**GENOA CHARTER TOWNSHIP
PLANNING COMMISSION
PUBLIC HEARING
September 9, 2013
6:30 P.M.
AGENDA**

OPEN PUBLIC HEARING #1... Review of site plan, special use, and environmental impact assessment for proposed 16,120 square-foot gymnasium and classroom addition for Brighton Nazarene Church, located at 7669 Brighton Road in Section 25, petitioned by Brighton Nazarene Church.

Re: Brighton Nazarene Church Facility Expansion
Site Plan Review
Boss File No. 13-100

Attention:	Kelly Van Marter, AICP Assistant Township Manager and Planning Director
Subject:	Brighton Nazarene – Special Land Use and Site Plan Review #3
Location:	7669 Brighton Road – northwest corner of Brighton and Aljoann Roads
Zoning:	SR Suburban Residential District

SHEET NUMBER:
A301

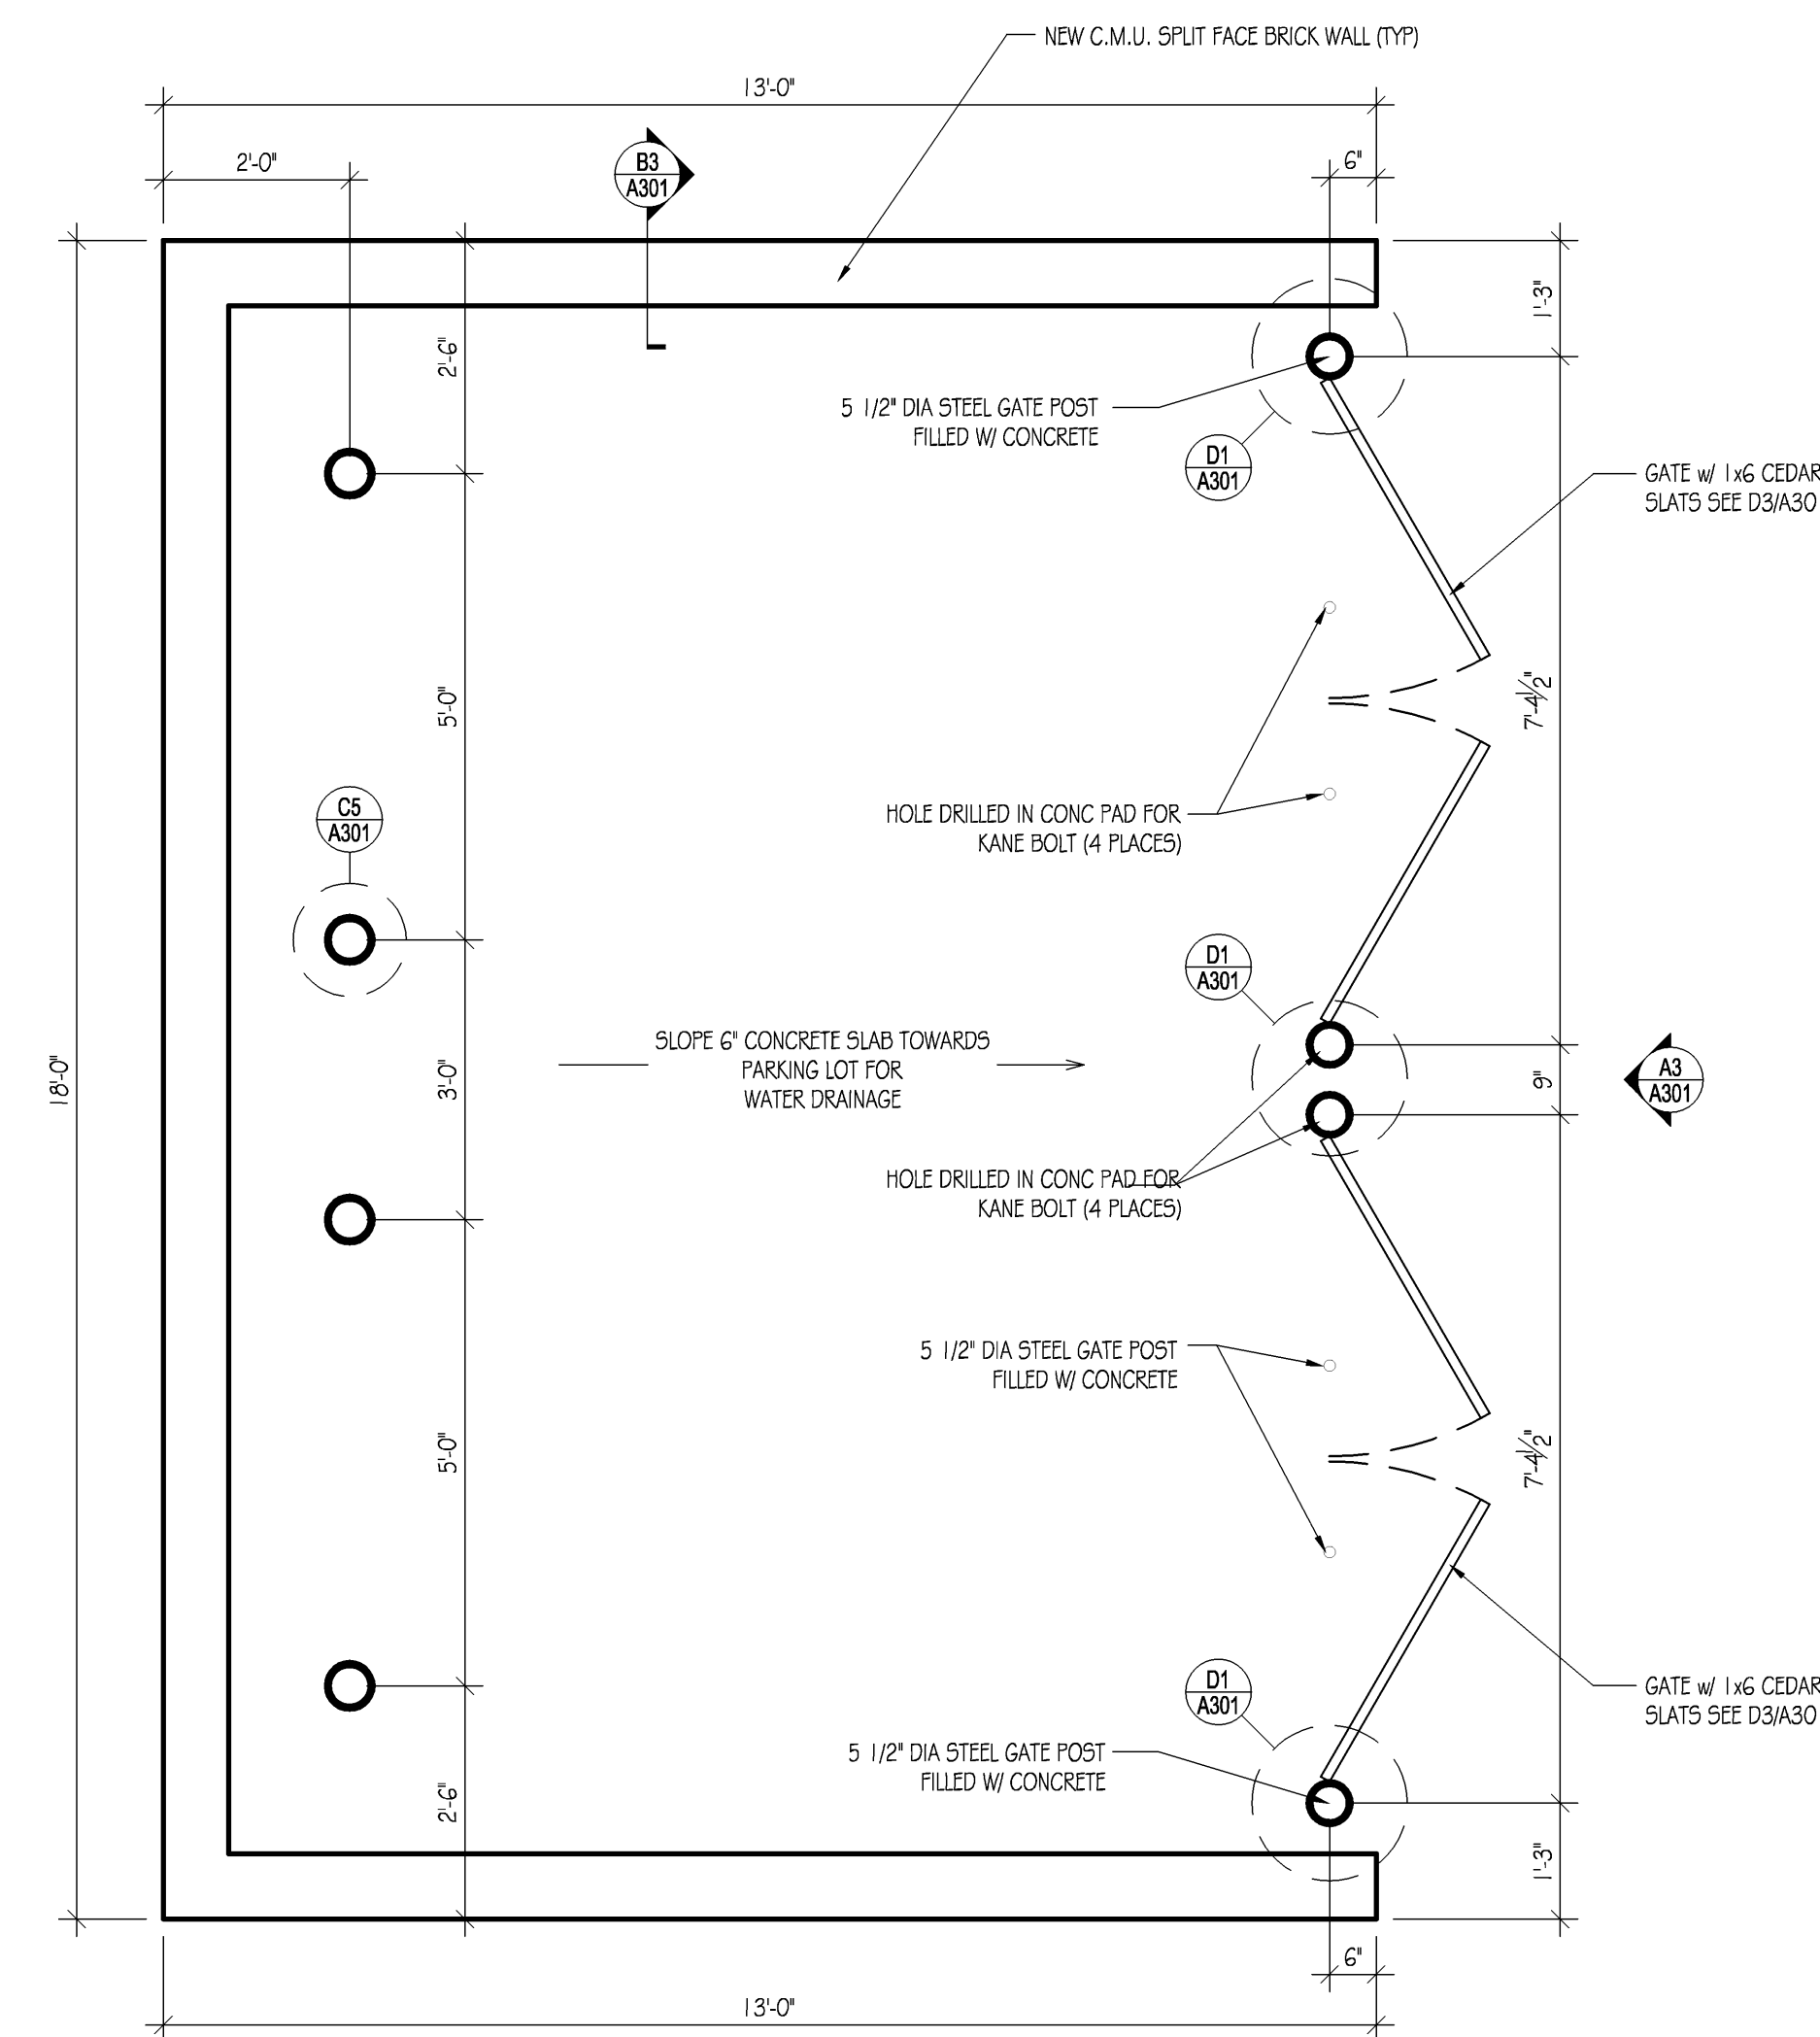
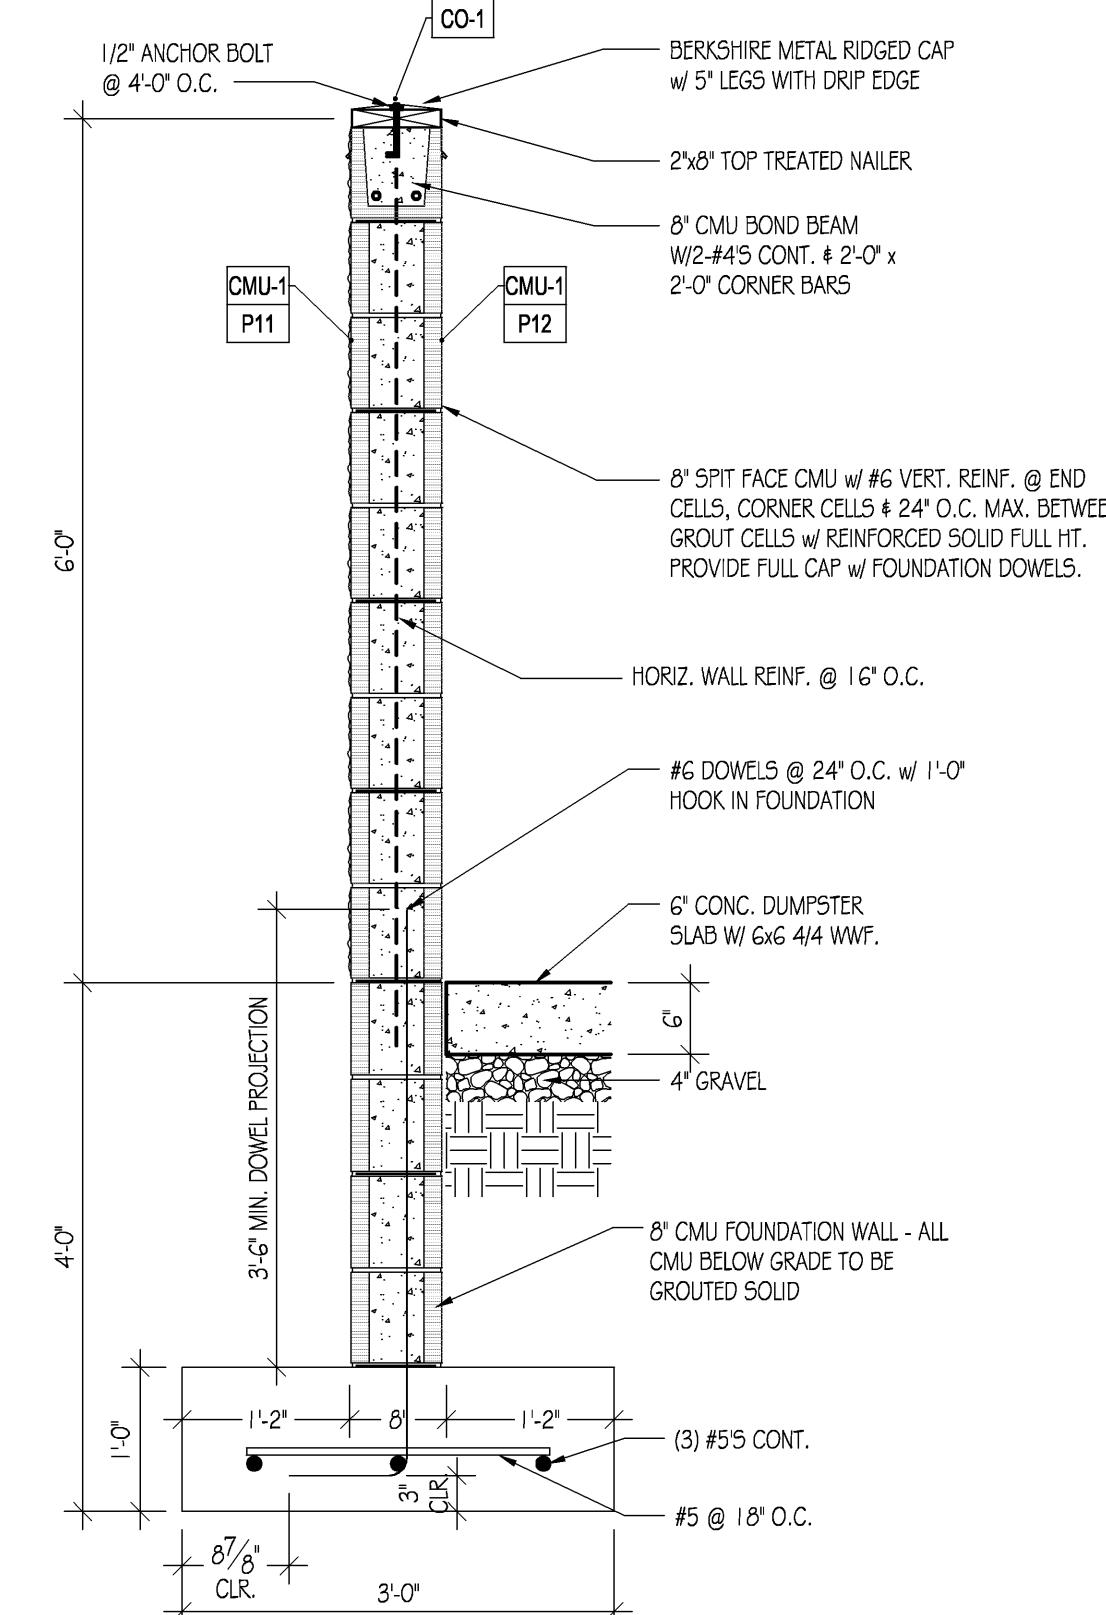
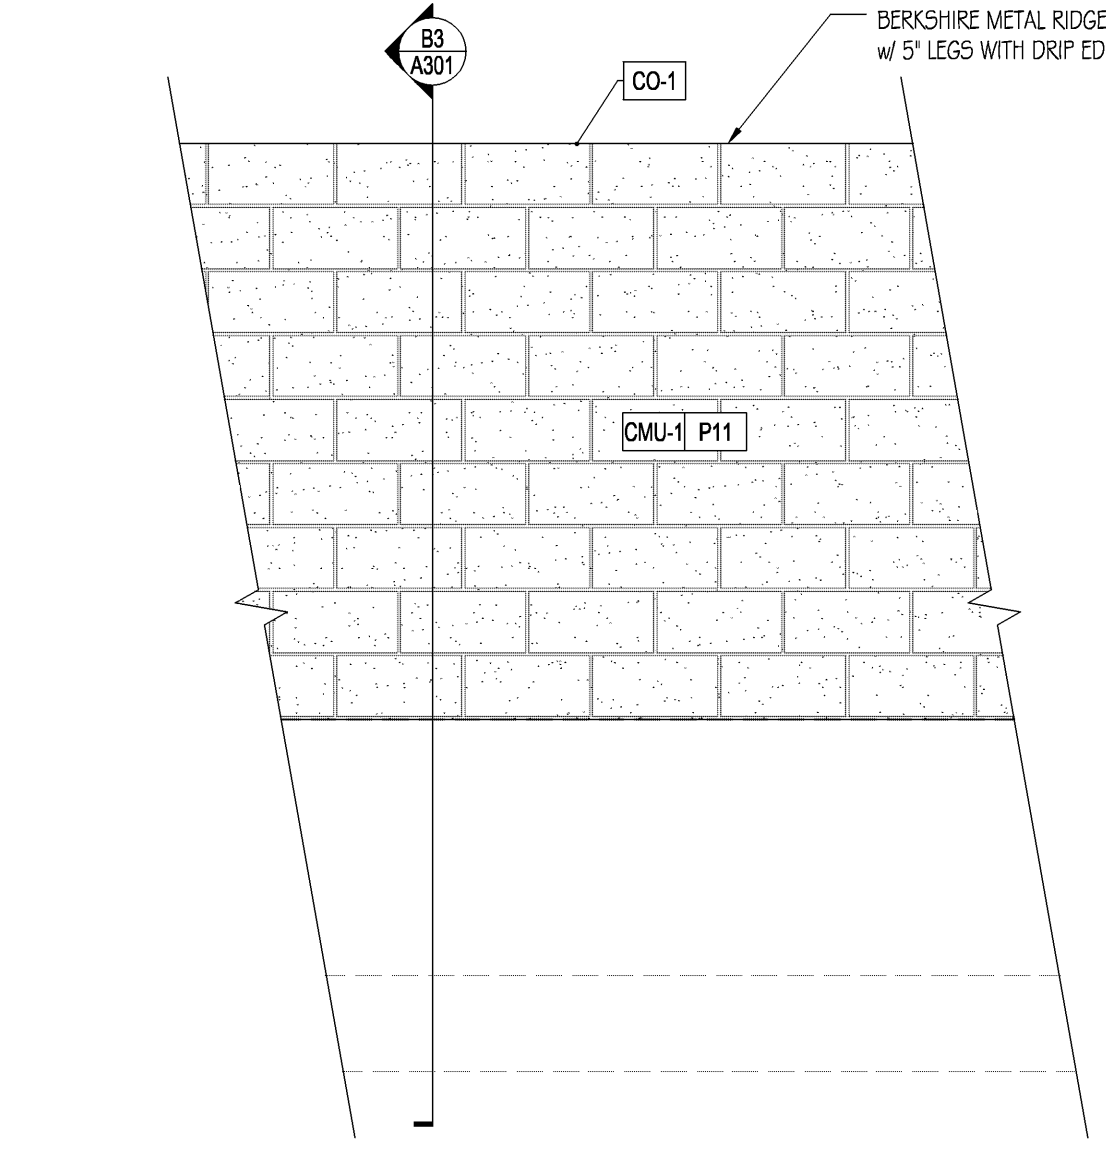
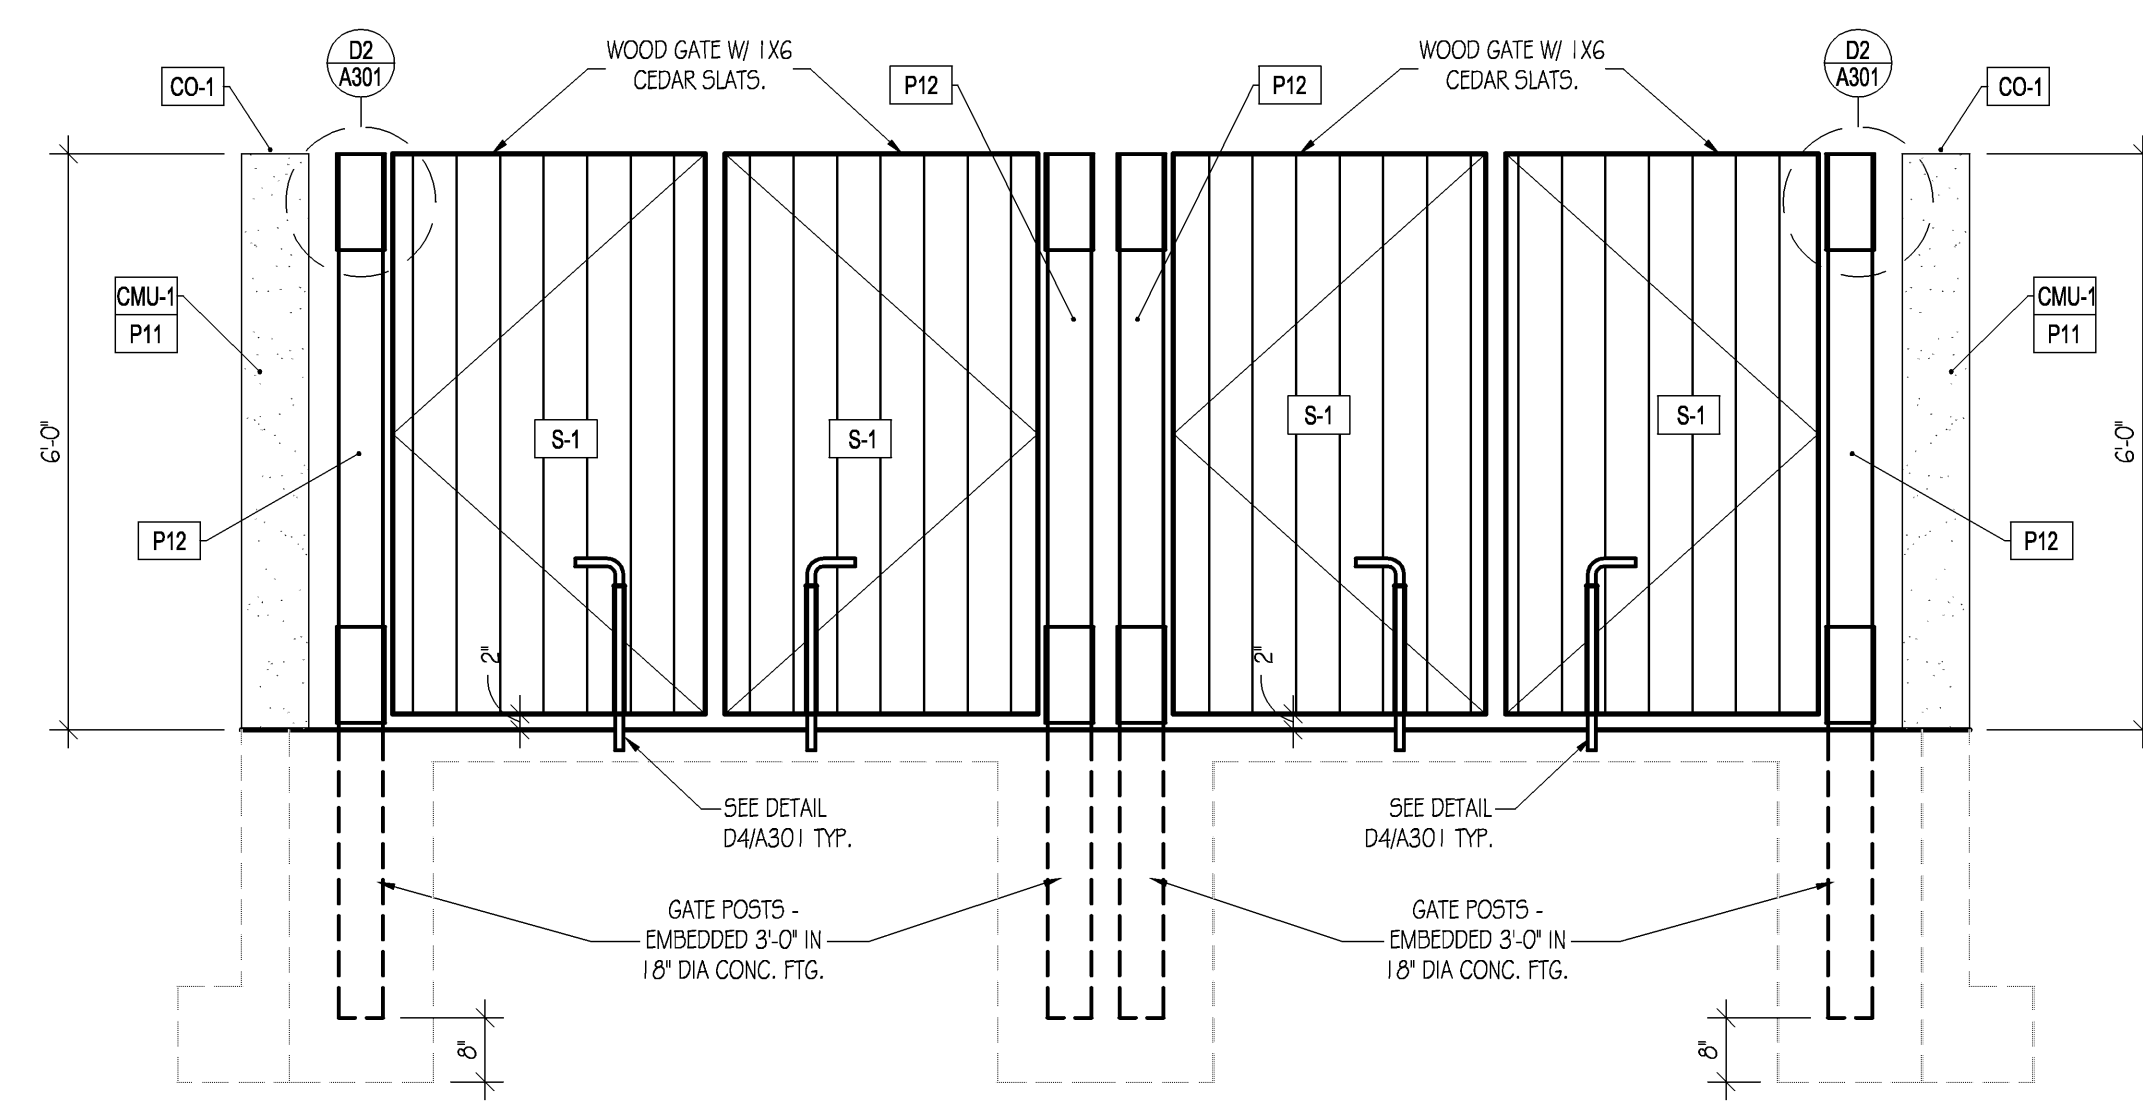
7. **Waste Receptacle and Enclosure.** The project includes enclosed waste receptacles northeast of the proposed building. The site plan identifies the required concrete base pad, while Sheet A301 identifies a 3-sided split face CMU enclosure with a gate across the 4th side. Generally, the Township requires enclosures to match the materials used on the building and there is no split face CMU shown on the elevation drawings. The applicant should utilize a face material for the enclosure that matches the building.
8. **Pedestrian Circulation.** The site plan identifies a concrete sidewalk within the Grand River right-of-way, as well as sidewalks around the perimeter of the building. Given the nature of the proposed use, the project could benefit from a pedestrian connection between the public sidewalk and building entrance.
